RE: **Signal Pointe Subdivision**
Release of Financial Guarantee Certification
Engineer's Stamp Date 7-21-2016 (File: C20D0070)

RE: **Signal Pointe Subdivision**
Pad Certification – All Pads
Engineer's Stamp Date 7-21-2016 (File: C20D0070)

GRADING & DRAINAGE PLAN

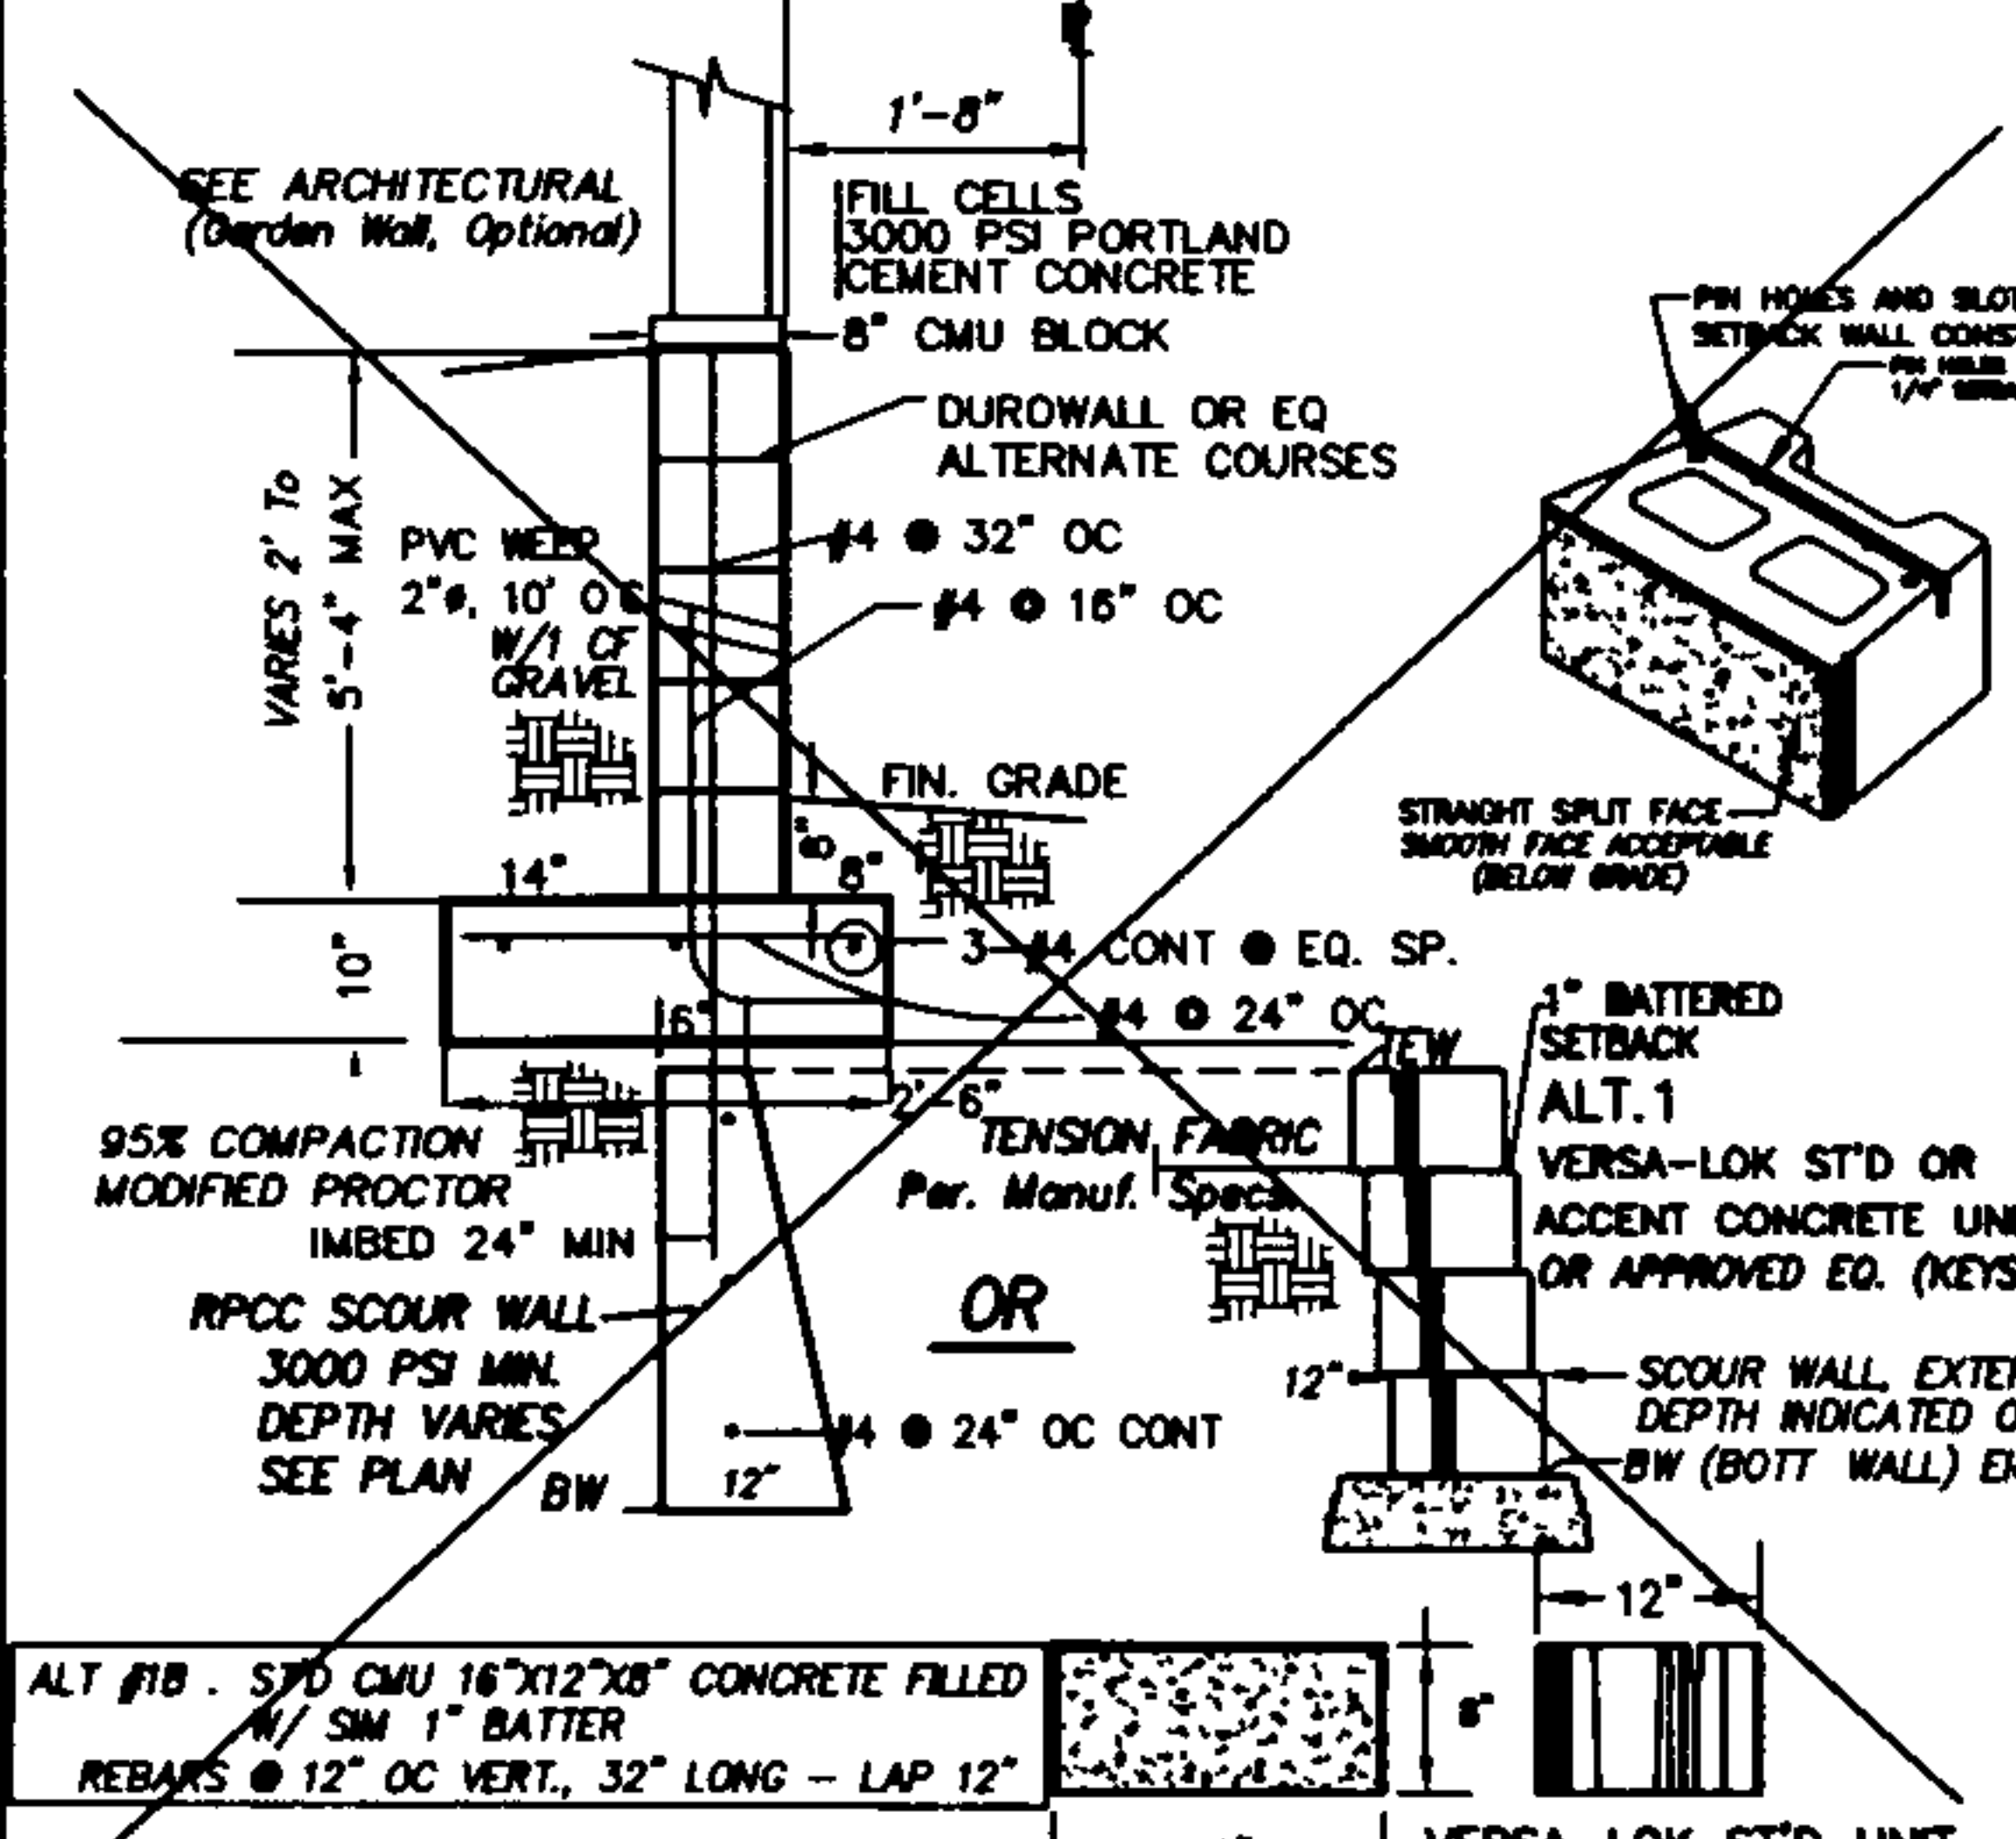
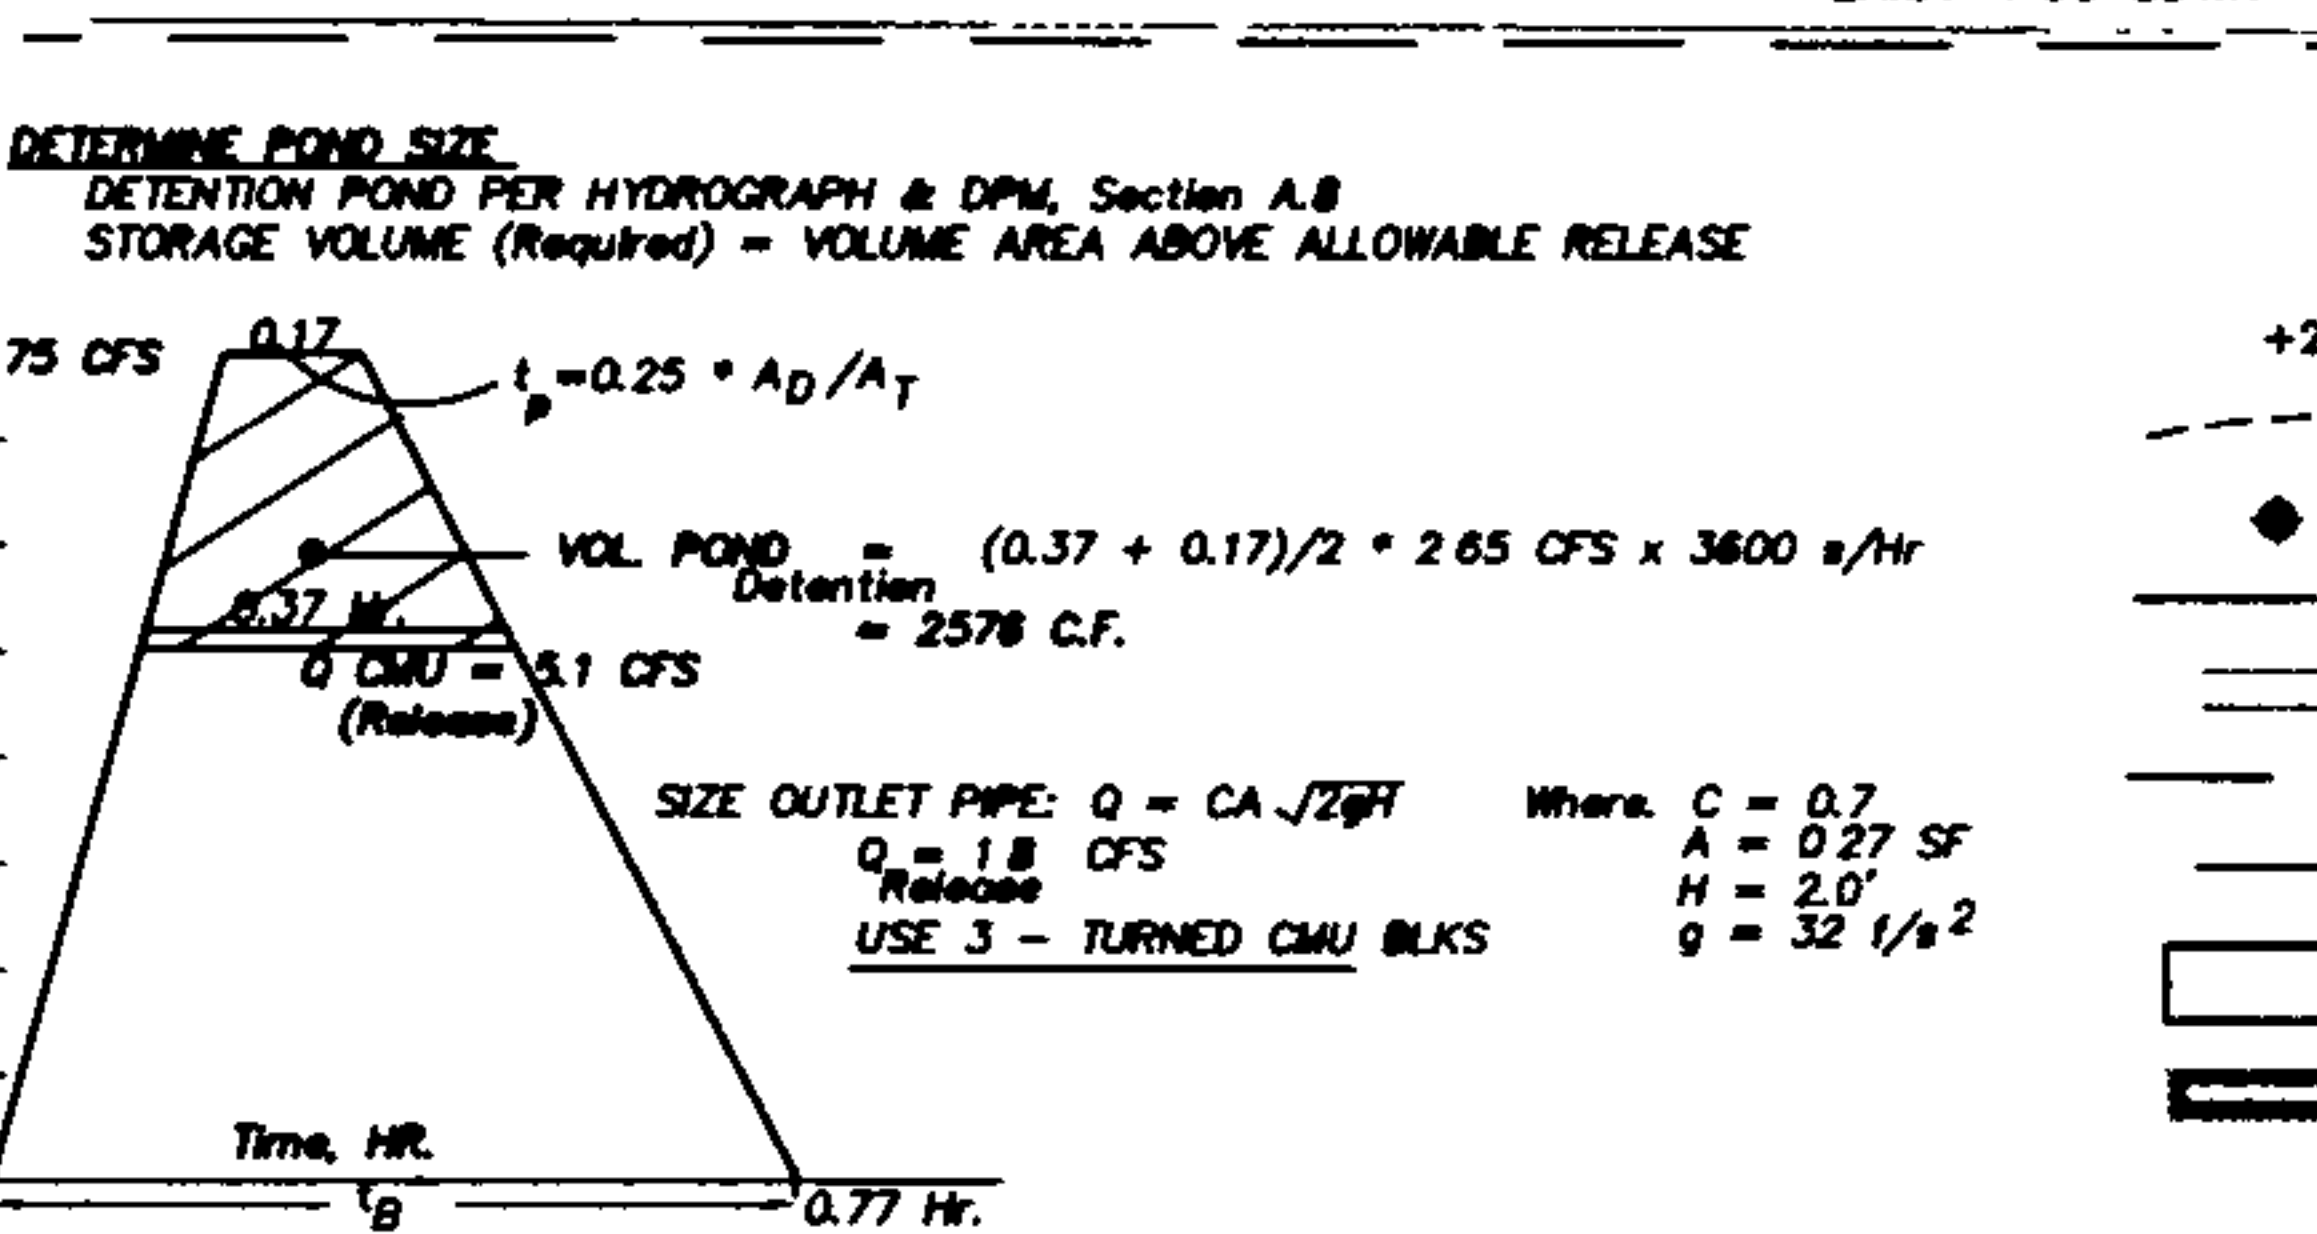
1. The turn blocks were not incorporated into the western wall, as an outlet for the water quality pond. This has the potential to adversely affect the home that is currently under construction on Lot 5 when the subdivision is built out. This will need to be addressed before any further action on this subdivision is approved (final plat, ROFG, future building permits).

Based upon the information provided in your submittal received 9-20-2016 (electronic copy received 7-21-2016), the above referenced Grading and Drainage Plan is approved for Release of Financial Guarantee. The conditions described in the Pad Certification are satisfied (turn blocks).
